**1958 Agreement – Consideration of draft amendments
to existing Regulations submitted by GRE**

Proposal for Supplement 7 to the 01 series of amendments to Regulation No. 45 (Headlamp cleaners)

Submitted by the Working Party on Lighting and Light-Signalling*

I. Arrangement of the approval mark for a headlamp cleaner

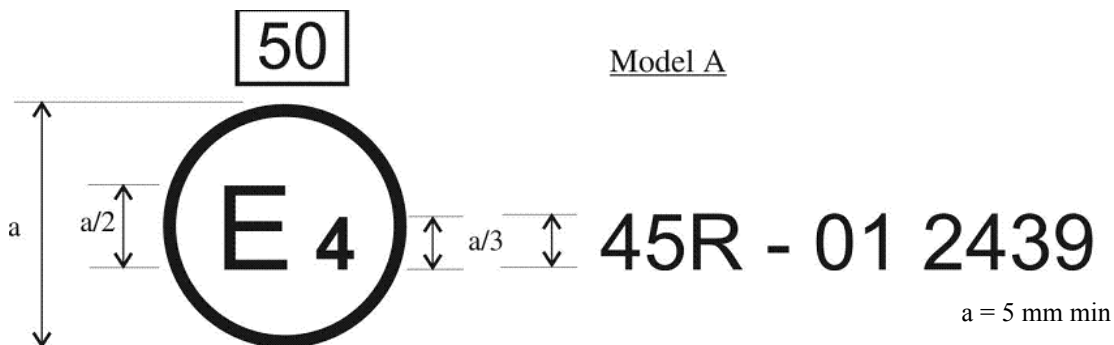
Annex 3, Figures 1 and 2, amend to read:

The above approval mark ... as amended by the 01 series of amendments.

Note: The approval number ... , in order to prevent any confusion with other symbols.
